STAFF REPORT

FILE NOs: DVP-2024-02 & DP-2024-15

SUBJECT: Variance applications and form and character Development Permit for a mixed-use apartment residential development and daycare at 718 North Rd

REPORT FOR ADVISORY DESIGN PANEL RECOMMENDATION TO COUNCIL

Figure 8 - Grade level plan, excluding surface parking south of the buildings.

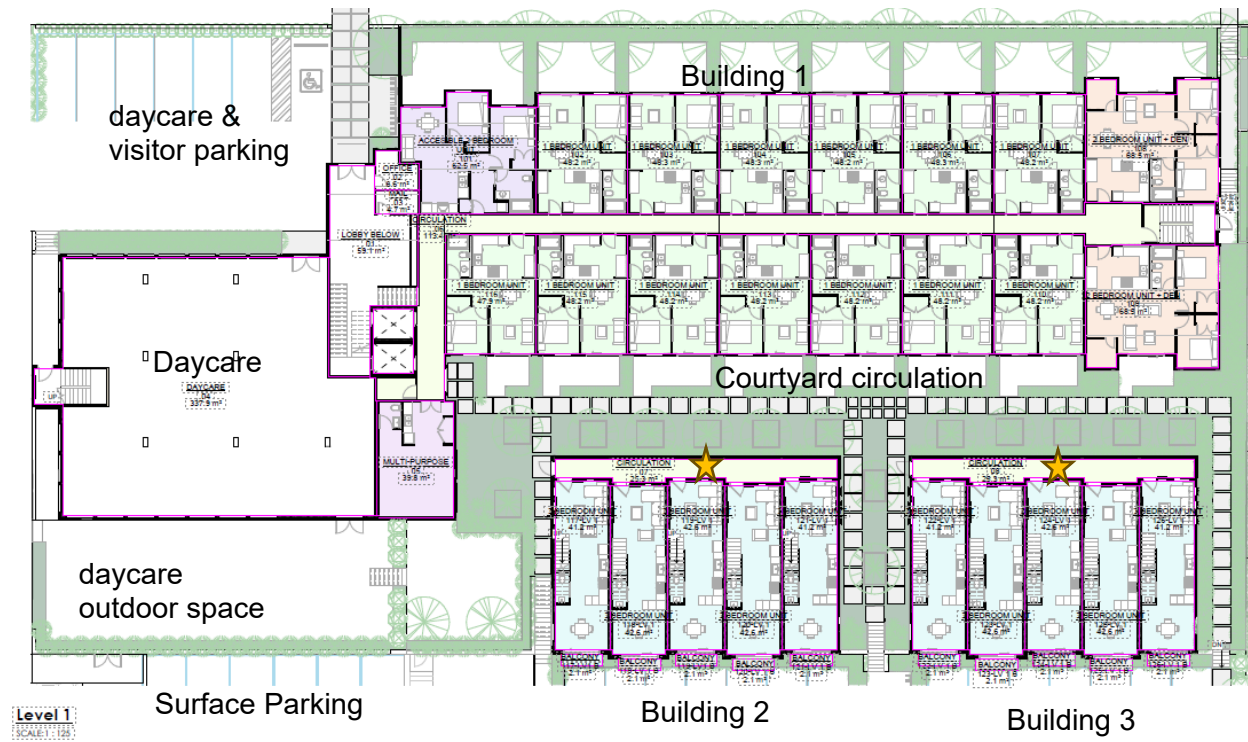
The five (5) three-storey townhouse-style apartment units in each of the east side buildings are connected by a common corridor facing the interior courtyard. Without the corridor providing a common entrance, the units would be townhouse units per the Bylaw, not allowed under the property’s C1 zoning. To allow individual access at grade, a zoning and OCP amendment is required to allow townhouse use. This option was suggested by staff, however the applicant has chosen to proceed through a design modification and variances within the C1 zone as a requirement of their development financing is that the zoning for the development is in place.

The common corridors are shown in the grade level plan above, marked with a yellow star (Figure 8).

Figure 10 - North Elevation, adjacent to a vacant neighbouring property fronting North Road and a single family residential property Fronting Cascade Crescent.

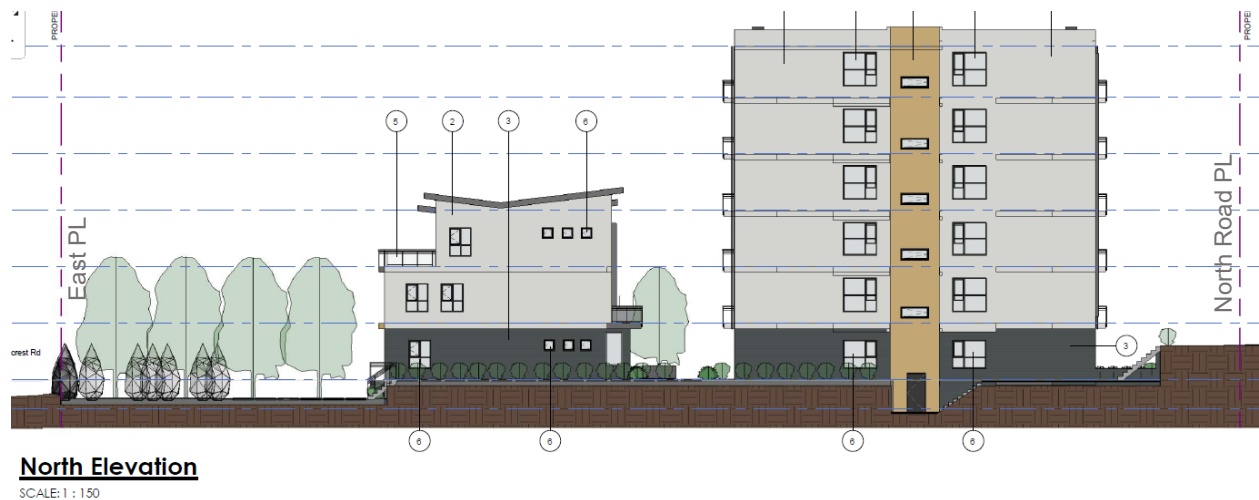
Figure 9 shows the development as seen from the neighbouring residential properties to the north. No stepping of the building height is proposed for the apartment building on this frontage. A 2 m setback from the neighbouring properties is being requested (instead of the required 6 m), accommodating a walkway from the street to the sunken north side entrance of the apartment building, but very little opportunity for buffer plantings beyond a shrub hedge.

The six (6) stories of the apartment building, with small setbacks and no stepping on the north side will also impart shadow impacts to the neighbouring property to the north.

Figure 11 - Overview of landscape plan

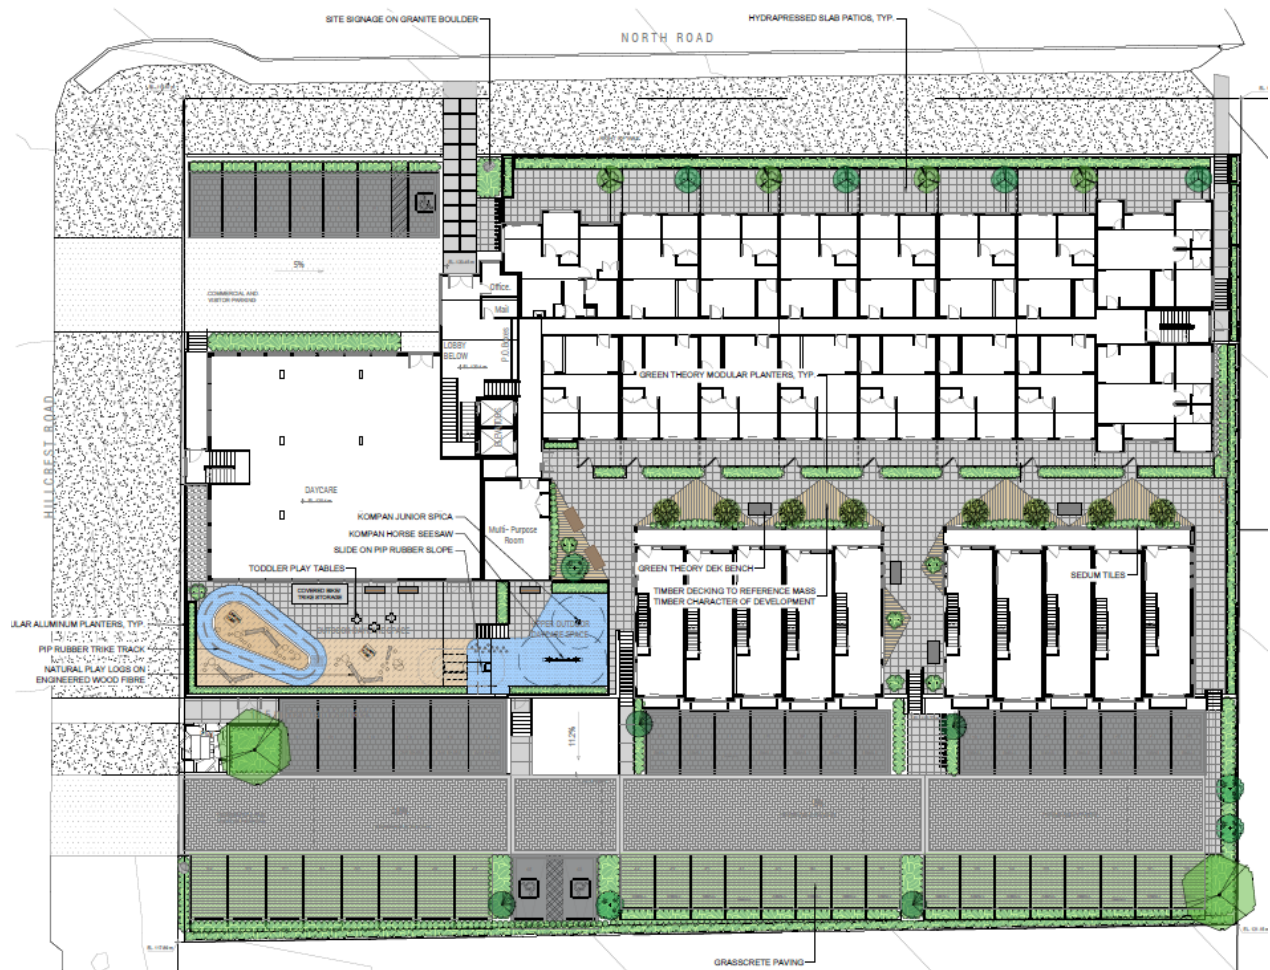
The referral comments provided by Vancouver Coastal Health recommend more tree plantings to provide shade, buffer vehicle pollution from parking areas and North Road and to provide climate mitigation for the development – notably over and/or around the children’s play area, which includes no proposed tree cover.
